MINUTES
DETROIT HISTORIC DISTRICT COMMISSION REGULAR MEETING
October 8, 2025
Coleman A. Young Municipal Center, Suite 808

DISTRIBUTED TO COMMISSION
RE 2233 PARK,
10/8/25

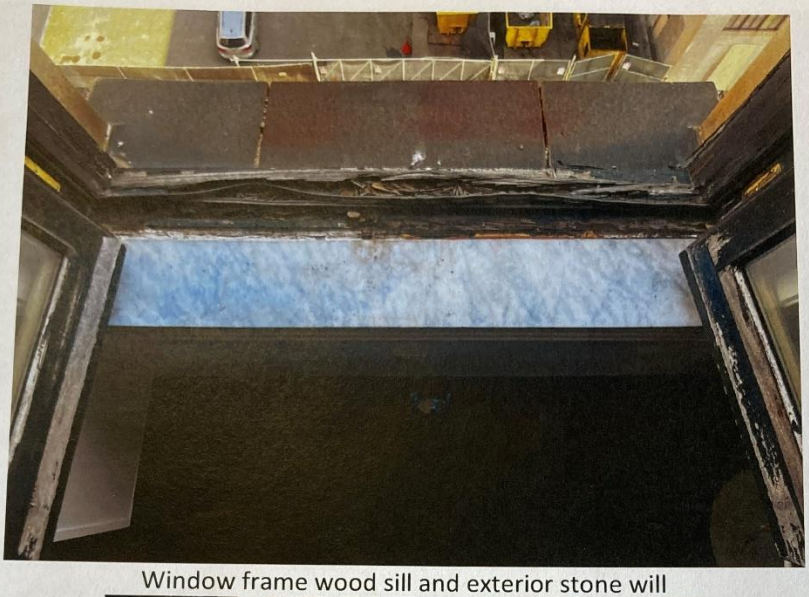
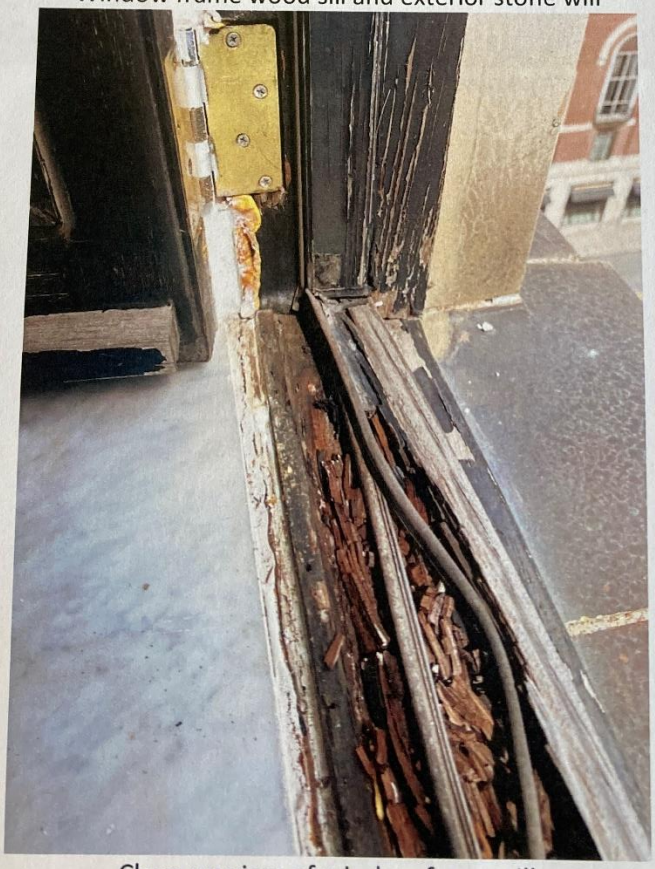
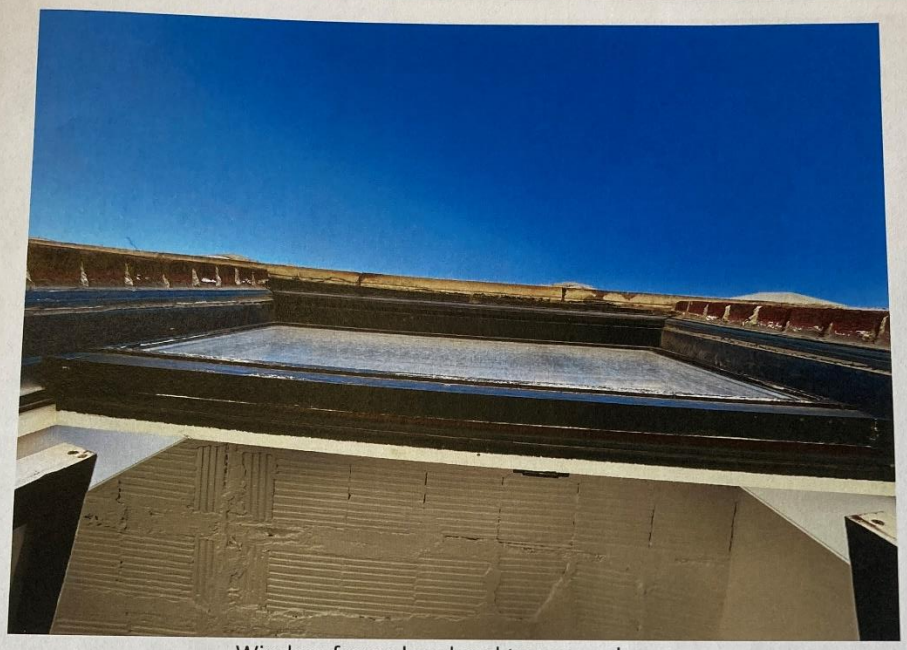
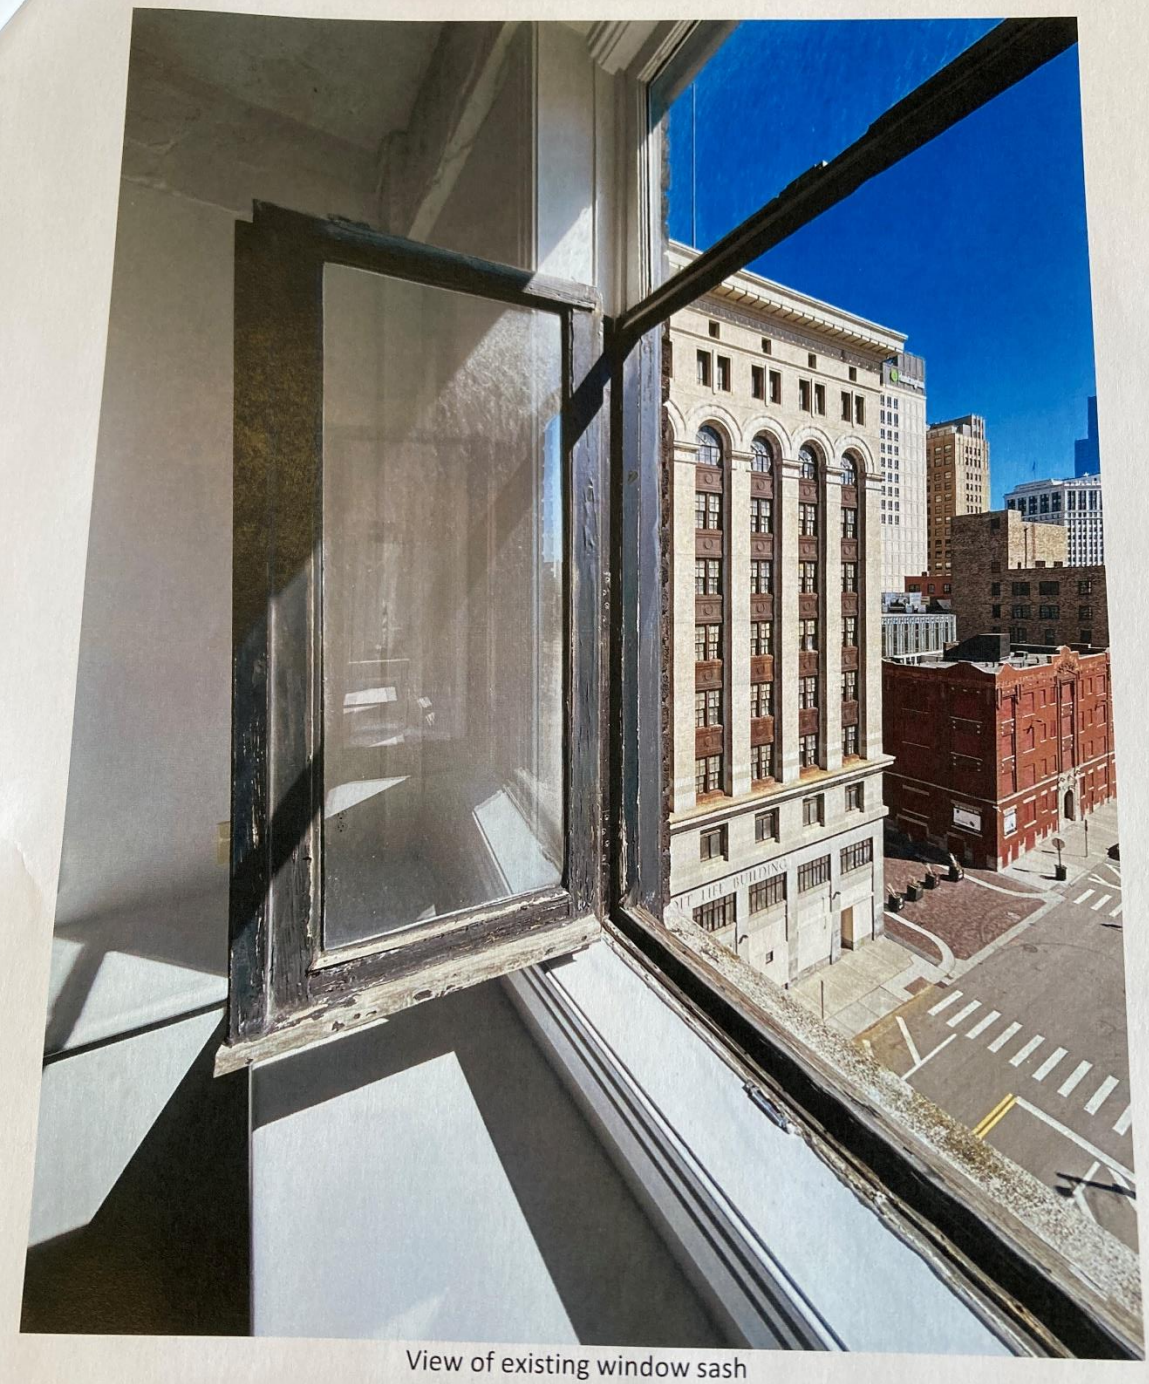
2233 Park – HDC2025-00591 – Park Avenue Local HD – AD **–** Replace wood windows with aluminum-clad wood windows
Steven Flum, architect, Sean Harrington, present and sworn in.
Mr. Flum stated that the windows really are beyond repair. They have proposed a different window replacement, but this time are proposing a window with a vertical grill in the lower sash to better replicate what is there, and the brick mold with this window is almost identical to the historic.
Commissioners and applicants discussed operation. Could the transom above open (awning or hopper) and the window with the muntin or meeting rail be fixed in place? Director Landsberg offered clarification that with replacements, the visual matching of the new window to the historic is more important than the operation, by National Park Service guidance.

- the proposed vertical strip on the lower sash of the cottage window will be six inches wide rather than three inches wide.

[The edge profile of that muntin will be ogee as proposed in the application.]
